826-2898 Honeywell to Fenwal Module Conversion Instructions

Follow these instructions to install the enclosed Fenwal spark module, 807-5244. It is a replacement for a Honeywell module, 807-4383. The function is the same.

Figure 1

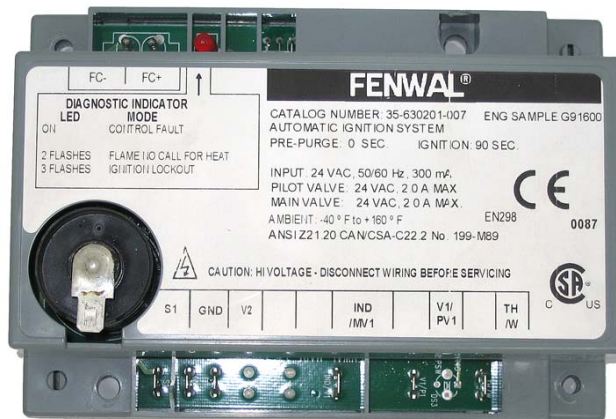
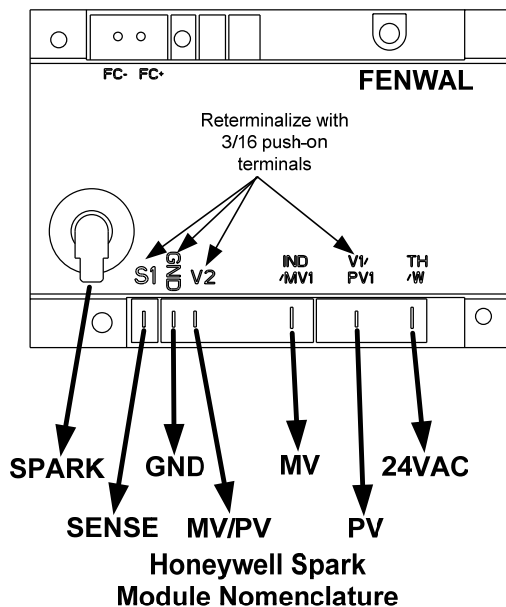
- Remove power from the unit.
- Label wires before removing existing spark module.
- Discard the extra ground from position 24V (GND). It is not needed on the new module.
- Remove existing spark module.
- Replace the existing terminals on wires GND, V2 (MV/PV), S1 (Sense) and V1/PV1 (PV) with enclosed 3/16" push on terminals.
- Mount the provided spark module, noting these nomenclature differences (see below and Figure 1) and on the housing when reattaching the wires.
- Restore power and test.

Connection Differences

Honeywell	Fenwal
MV	IND/MV1
MV/PV	V2
PV	V1/PV1
GND	GND
24V (GND)	Discard – Wire not needed
24V	TH/W
SPARK	HV (SPARK)
SENSE	S1
